FUJIKURA FIBER OPTICS VIETNAM LTD.								
4M AMENDMENT REQUEST AND RECORD								
Form: 4-Pr-	007-4-Fo-001		Version: 15	5 P	age 1/4			
Requested by: TramNTN						Issued date: 13-Aug-2021		
	Record No. (get	by EIC program	n):	4-PR-	007-4-FO-00°	1-4-RC-0965		
	Record name: A	Apply cancel gr	inding for hyt	rel tube	of FSC Serie	es product		
A - Information of amendment:								
A.1 Topic fo	or 4M amendment	recommendati	on:					
	Man	□ Materi	al 📮	Metho	d/Document	□ Machine, Tool/Jig		
	Process	□ Suppli	er 🗆	Factor	y/Section	□ Others:		
A.2 Detail in	nformation: (For	document, plea	se write down	documer	nt number, cu	rrent version fully)

4M AMENDMENT REQUEST AND RECORD

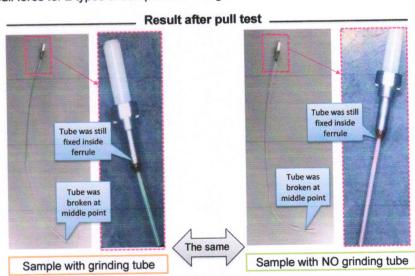
2. Cancel grinding hytrel tube gives a same strength for fixing between hytrel tube and ferrule Refer Pull test result: Samples of grinding tube & No grinding tube are the same

- + Hytrel Tube was still fixed inside ferrule after testing.
- + Hytrel Tube was broken with the same pull force for 2 types of sample after elongated about 300 mm

=> No risk of tube come out after ferrule assembly with current handling process

Connector side was wired inside module case so there is no outside force impact to the tube pull out of ferrule inside module => Have no risk tube came off after assembly
